Reviewer 1

“This work presents a boundary optimal control strategy for axial tubular reactors with first-order irreversible chemical reaction incorporating a delayed recycle stream. The mathematical description takes the form of a system of coupled parabolic and hyperbolic PDEs. An infinite-dimensional approach is applied to derive a linear quadratic regulator with and without observer. Numerical studies show that the proposed controller is able to stabilize the system. The manuscript is clear and well written and addresses a challenging control problem in chemical engineering. The following comments and suggestions may improve the presentation so that it is considered for publication.”

Figure 1: Concentration profile along the recycle stream

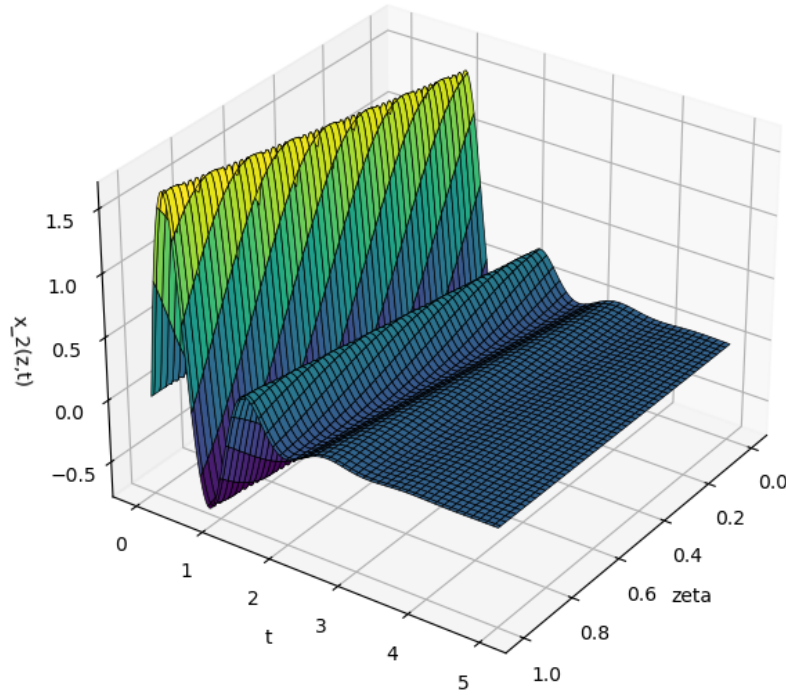
6. Page 7 - " $x_2(\zeta, t)$ is introduced as a new state variable to account for the concentration along the recycle stream"

- Why is x_2 a function of ζ ? How does x_2 change across the recycle? What kind of law does it follow? To me, it seems like x_2 only changes with respect to time

We have assumed that along the recycle stream, the flow of the reactant belongs to the class of pure transport PDEs. This is the case when the diffusion term and the reaction term become negligible compared to the convective term, and the state variable x_2 is merely being transported along the recycle stream. Nevertheless, this still implies that x_2 is a function of ζ and t . Concentration profile along the recycle stream has not been presented in the original submission as we believe it is not the focus of this work. However, for the reviewer's reference, it is included here in the response as shown in Fig. 1.

Figure 2: Axial tubular reactor with recycle stream.

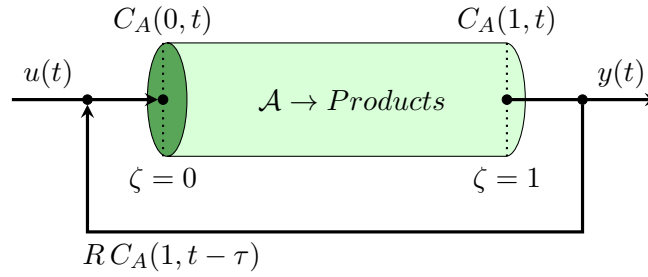
11. Page 18 - unstable dynamics of the model

- Why is the zero-input response considered unstable? Is it a qualitative assessment? What is the physical meaning of Figure 9?

For the axial dispersion tubular reactor presented in Fig. 2, the molar balance equation may be written for the reactant concentration, C_A , as follows:

As a result, the zero-input response is considered unstable due to the positive reaction term in the model. Figure 9 illustrates the unstable dynamics of the linearized model in the vicinity of the steady-state in the absence of control input; with the qualitative assessment that a deviation from the steady state may draw the system to a different steady state, resulting in completely different model dynamics than the one used to design and control the system for optimal operation. The manuscript has been updated to include more detailed explanation in this regard.
